**METROPOLITAN GOVERNMENT OF NASHVILLE AND DAVIDSON COUNTY**

**STAFF RECOMMENDATION**  
**1623 Fatherland Street**  
**September 18, 2013**

**Application:** New construction—addition  
**District:** Lockeland Springs-East End Neighborhood Conservation Zoning Overlay  
**Council District:** 06  
**Map and Parcel Number:** 08314011700  
**Applicant:** Van G. Pond, Jr., AIA  
**Project Lead:** Melissa Baldock, melissa.baldock@nashville.gov

<p><b>Description of Project:</b> The applicant is proposing to construct a rear addition to a historic house. The addition will be approximately four feet (4') taller than the shadow line of the house's roof. The project involves demolishing a non-contributing rear addition.</p> <p><b>Recommendation Summary:</b> Staff recommends approval of the project with the following conditions:</p> <ol style="list-style-type: none"> <li>1. The addition be no wider than the existing house;</li> <li>2. Staff review and approve the window and door specifications prior to purchase and installation;</li> <li>3. The HVAC and other utilities be placed in the rear of the property, or on a side façade beyond the midpoint of the house.</li> </ol> <p>With these condit

Figure 1. 1623 Fatherland.

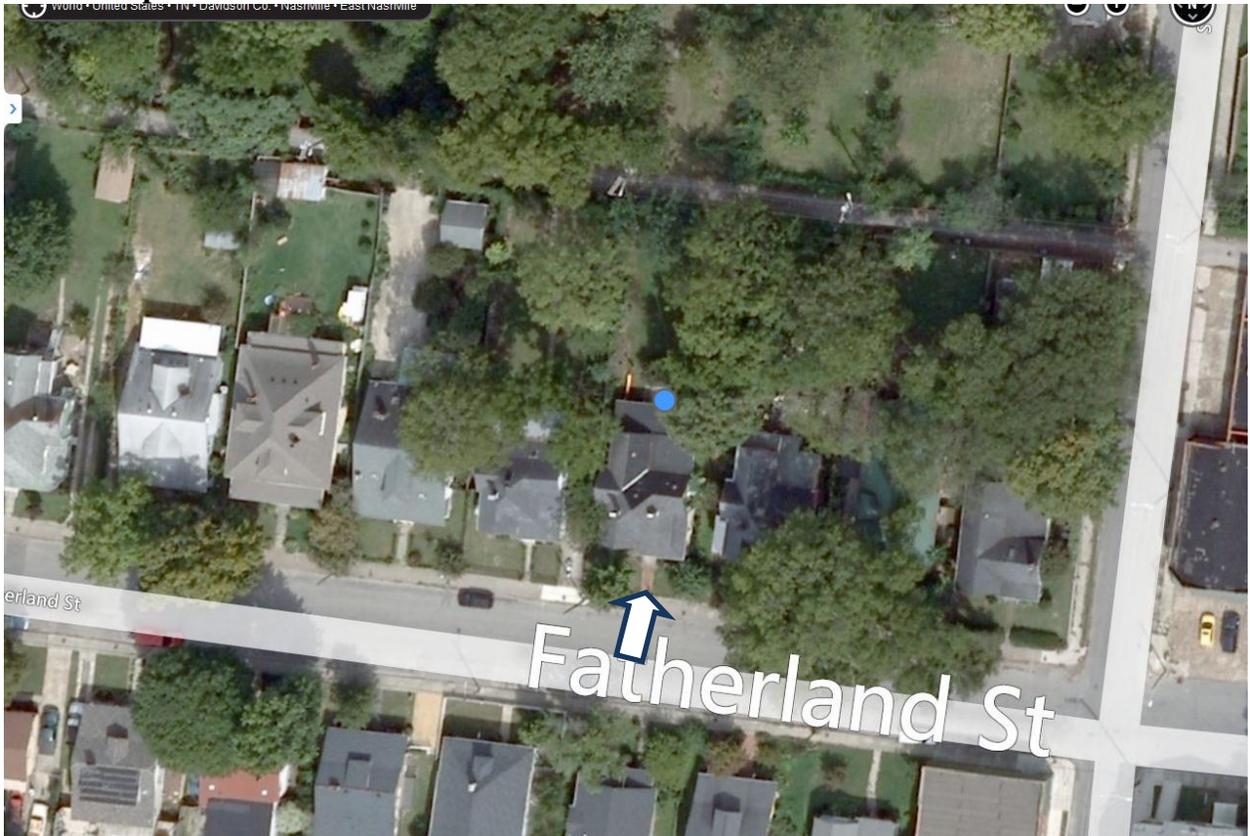
**Background:** 1623 Fatherland Street is a c. 1910 historic house with a gabled-el form (Figure 1). It is a contributing structure to the Lockeland Springs-East End Neighborhood Conservation Zoning Overlay.

Figures 2 & 3. The 1914 Sanborn map (right) and the 1951 Sanborn map (left). The 1951 Sanborn shows a portion of the addition that is to be removed. The addition that is on the right side of the house in the 1951 map will remain.

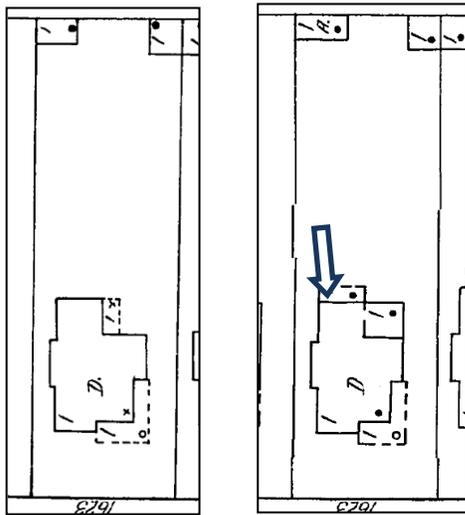
Partial Demolition. The applicant proposes to demolish a non-contributing and non-original rear addition to the structure. An analysis of historic Sanborn maps shows that the west (left) portion of this addition was built sometime between 1914 and 1951, and

the east (right) portion of the addition was constructed after 1951 (Figures 2-5). Staff finds that the addition that is to be removed does not contribute to the overall historic character of the house, and that its removal will not affect the historic integrity of the structure. Staff finds that the partial demolition meets Section IV.B. of the *Lockeland Springs-East End Neighborhood Conservation Zoning Overlay: Handbook and Design Guidelines*.

Proposed Main Floor Plan Renovations + Extensions

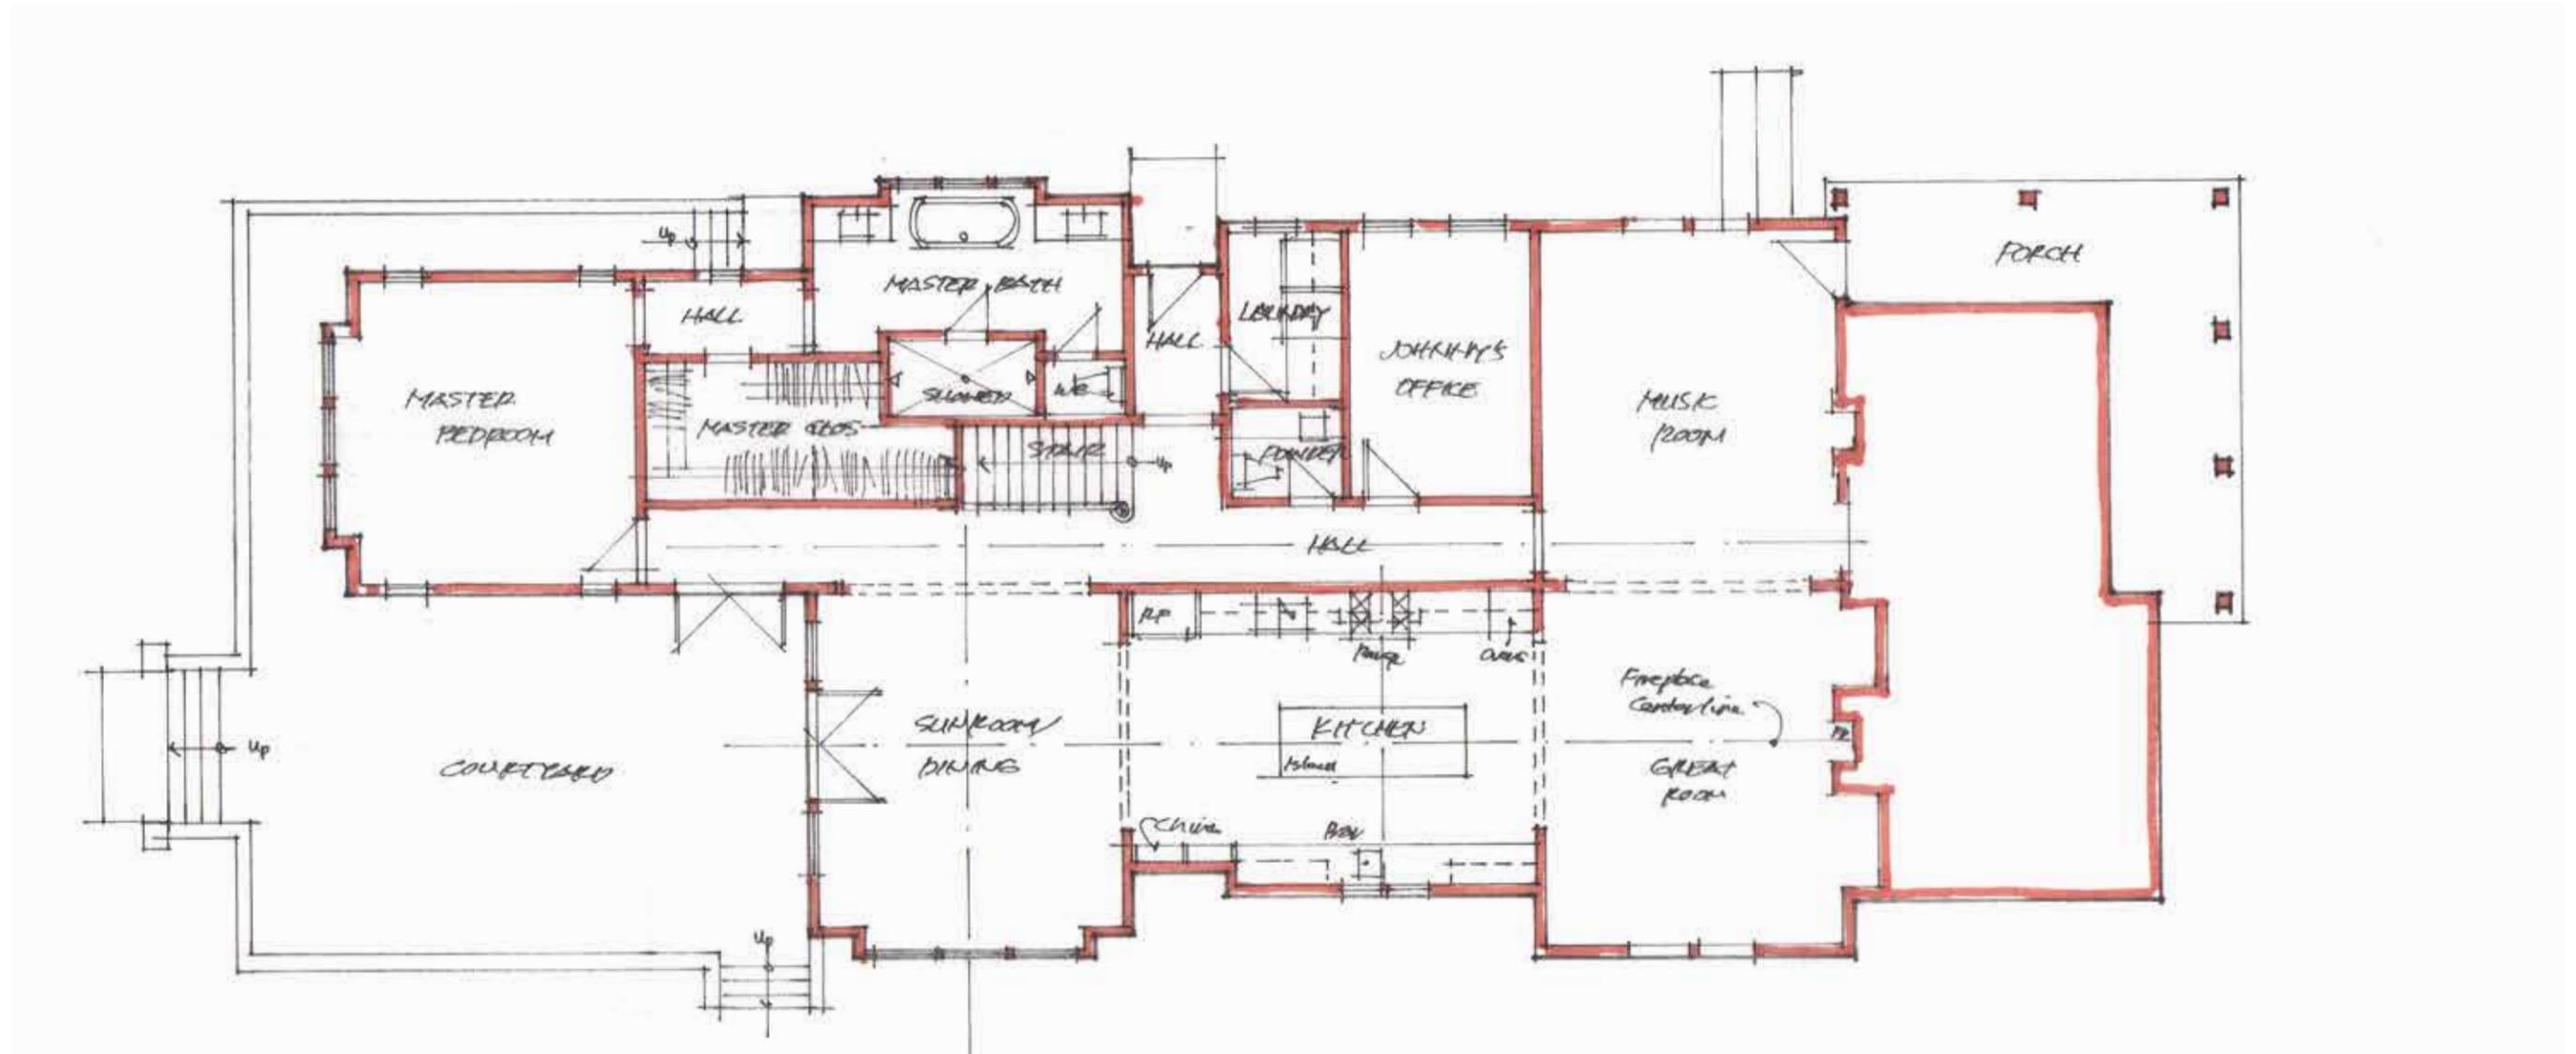
Height & Scale: The addition steps in from the back wall of the house one foot, six inches (1'6") on the west side of the house and two feet (2') on the east side. The inset has a depth of four feet, six inches (4'6") on both sides. After the inset, on the west side, the addition steps back out to match the line of the house's widest point. On the east side, after the inset, the addition steps back out to match the line of the porch. The east elevation includes a portion that extends approximately nine inches (9") from the wall of the house, and is therefore nine inches (9") wider than the house. Because the addition will be taller than the historic structure, the addition cannot also be wider than the historic structure. Staff asks that a condition of approval be that no part of the addition be wider than the historic house. The addition is proposed to have a maximum width of approximately thirty-six feet (36') and a maximum depth of approximately forty-two feet (42').

If the addition extends no wider than the existing house, staff finds that the proposed addition meets Sections II.B.1., II.B.2., and II.B.10. of the *Lockeland Springs-East End Neighborhood Conservation Zoning Overlay: Handbook and Design Guidelines*.

1. The addition be no wider than the existing house;
2. Staff review and approve the window and door specifications prior to purchase and installation;
3. The HVAC and other utilities be placed in the rear of the property, or on a side façade beyond the midpoint of the house.

Proposed Roof Plan Renovations + Extensions

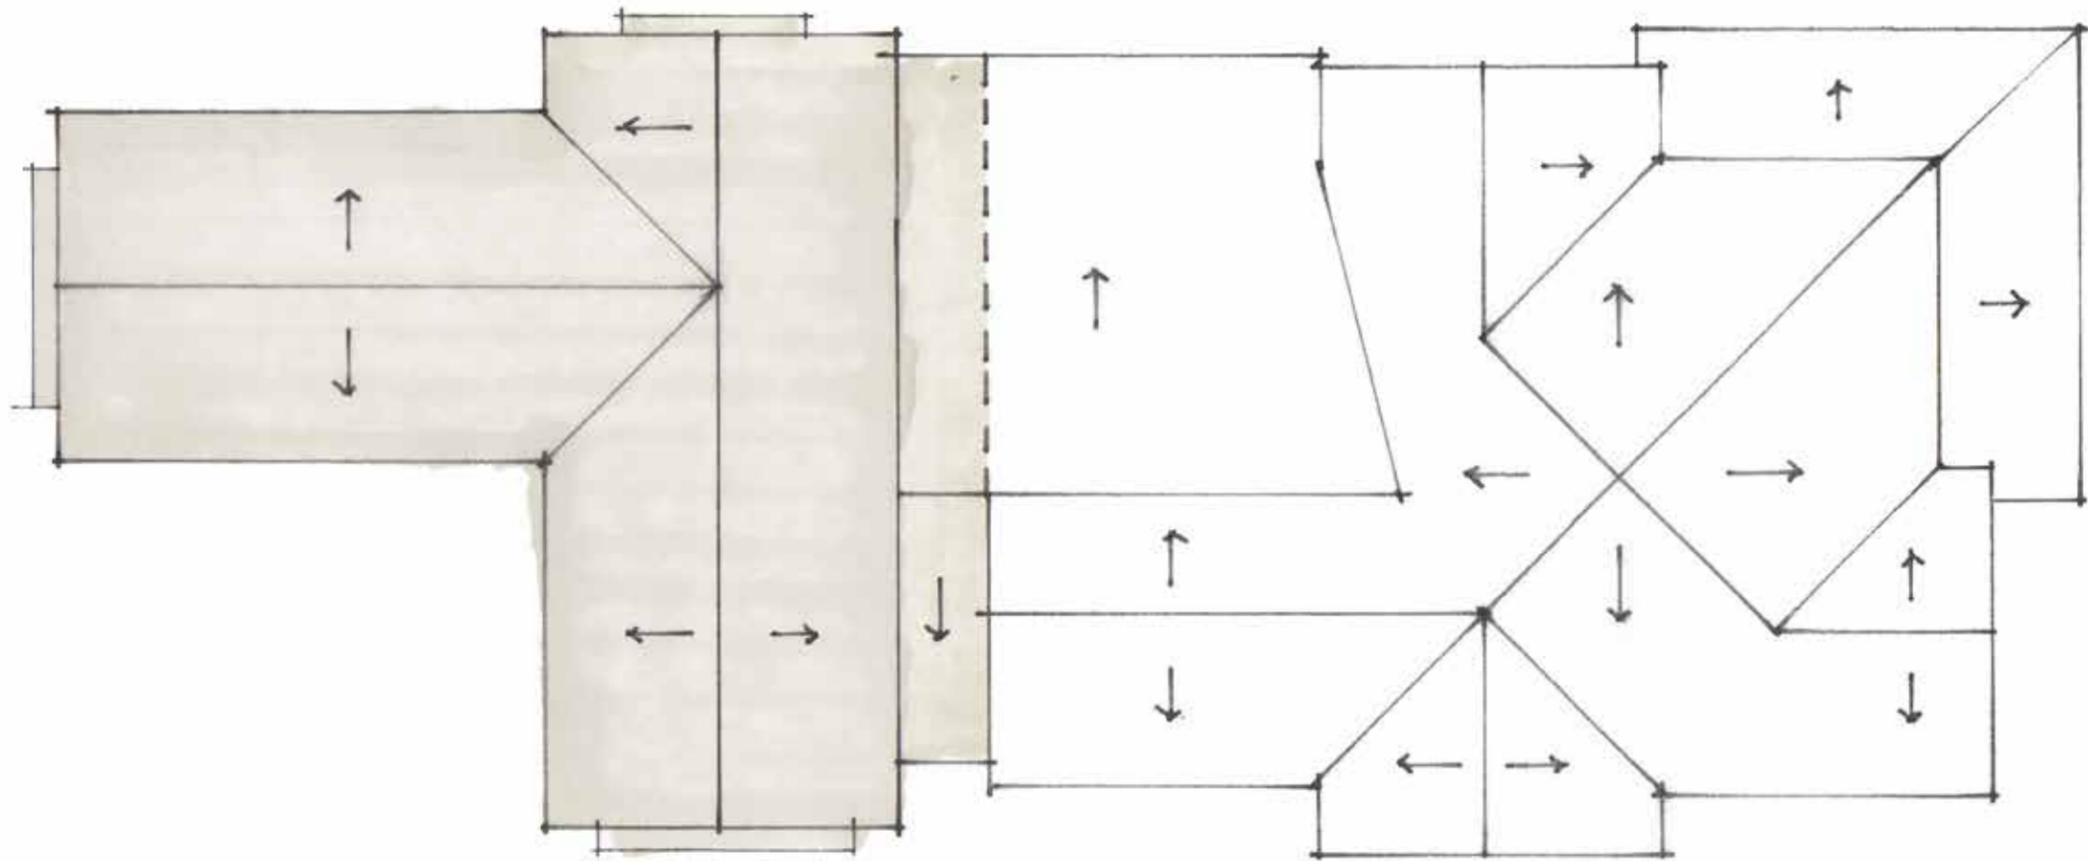
Roof: The existing house has a hipped roof with a cross gable. The house's historic slopes all have a pitch of 12/12. The addition preserves the complicated historic roof form. The inset connector between the house and the addition will have a shed roof. The main portion of the addition will have a cross gable form with a slope of 12/12 to match that of the existing house. Staff finds that the proposed addition appropriately preserves the historic roof form of the house and that the addition's roof forms are appropriate to the historic structure and the Lockeland Springs neighborhood. Staff finds that the roof

form meets Sections II.B.5. and II.B.10. of the *Lockeland Springs-East End Neighborhood Conservation Zoning Overlay: Handbook and Design Guidelines*.
